**Noise Assessment - 832 Hobart Road**

**Additional Information Required for Planning Application P16-052 - Tourist facility (visitor accommodation, caretaker's dwelling/reception, wastewater treatment system & 4 signs) at 832 Hobart Road, Breadalbane**

Planning Application P16-052 832 Hobart Road Breadalbane

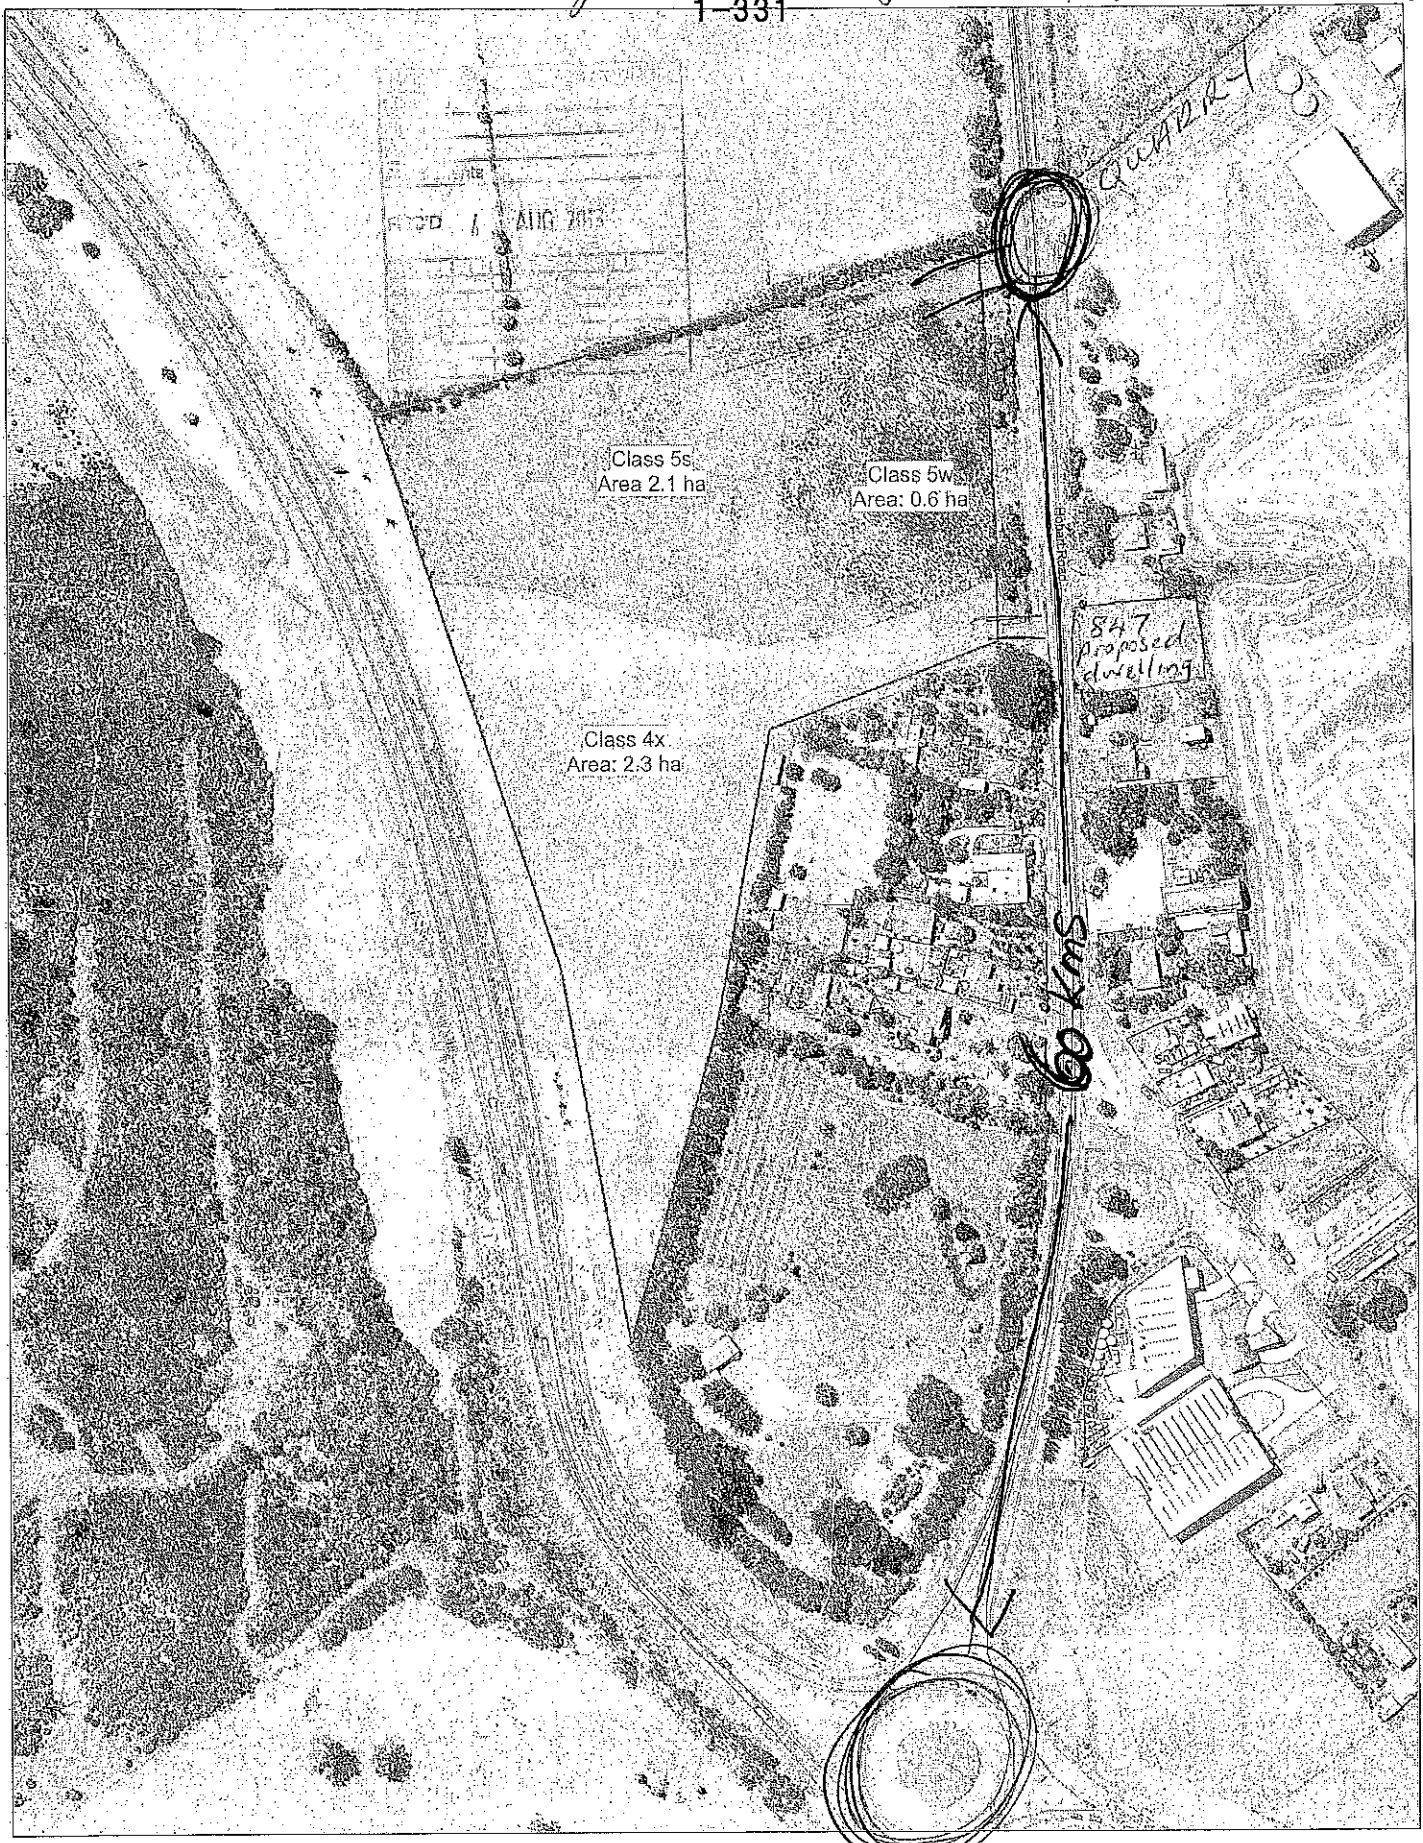
6. If the development is to go ahead I would like to propose, as per attached drawing on Land Capability Assessment, the entrance to the proposed development be at the Northernmost entrance into the park, along with the reception, and 2 x caretaker units. I further propose a round about be established for ease of entry for Raeburn Rd and proposed guests in the development to easily access Hobart Road and not impact on residents at that point.

7. As per attached drawing on Land Capability Assessment I, once again, request council to consider safety of all residents, especially children accessing school buses to finally make the necessary sensible decision to lower the speed limit to 60 kms per hour. I propose this between the two roundabouts as mentioned above if that comes to fruition.

Site Plan 1.

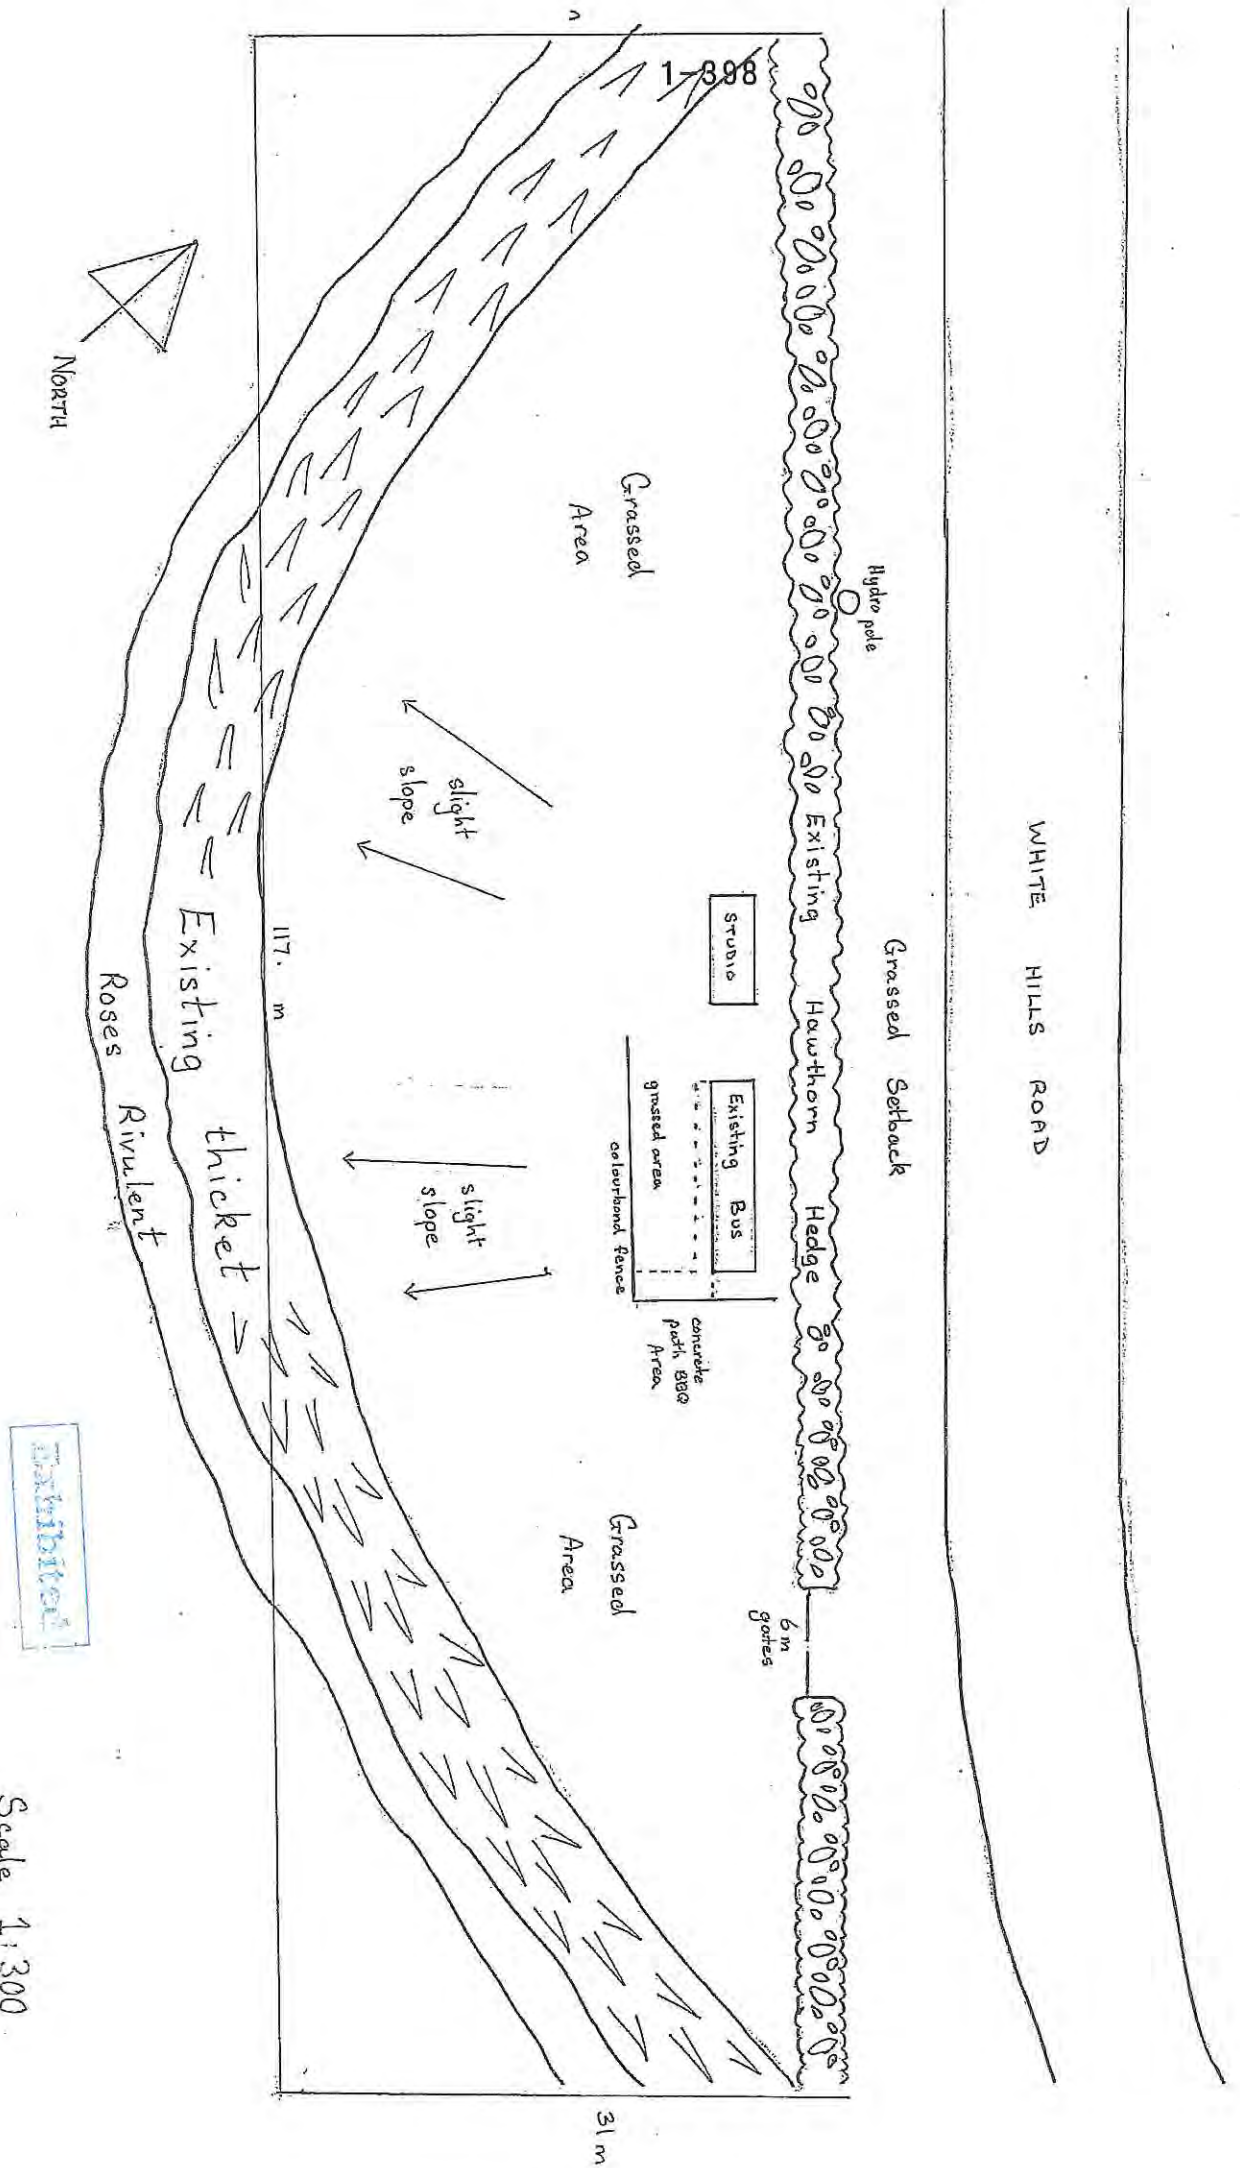
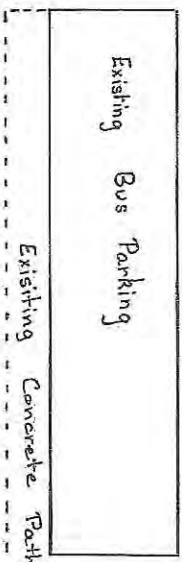
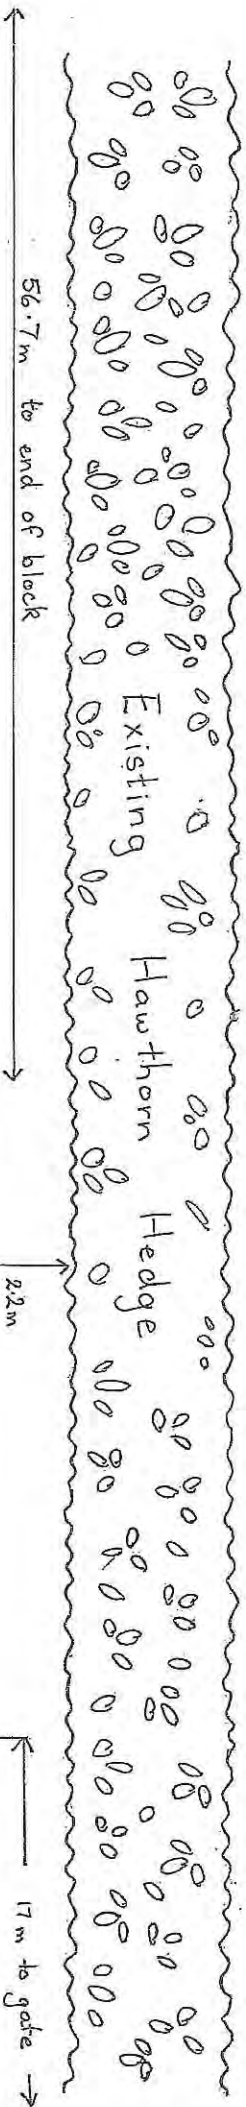
The site plans provided at 1:400 and 1:1000 also do not scale correctly (ie. the 6.1m shipping container scales at 17m long on one drawing and 13.5m on the other).
